Access Compliance Report Public Rights-of-Way (Curb Ramps)

Intersection ID: 13133 Main Street: S_CALDWELL_ST Cross Street: E_STONEWALL_ST Location: E

ADA ID: 1F78AB27B072 Ramp Type: BlendTrans1 Initial Pass/Fail: Pass Overall Compliance: No Severity Score: 20.25

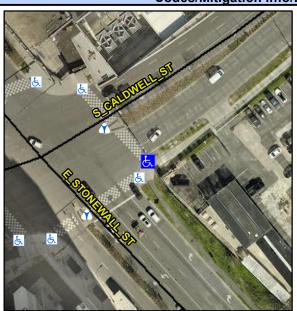
R304.5.3, R302.7.2, R304.5.4, R302.3, R402.2

Remove & Replace Curb Ramp With
Two New Directional Ramps or
Equivalent. Remove & Replace
Gutter. Utility Present.
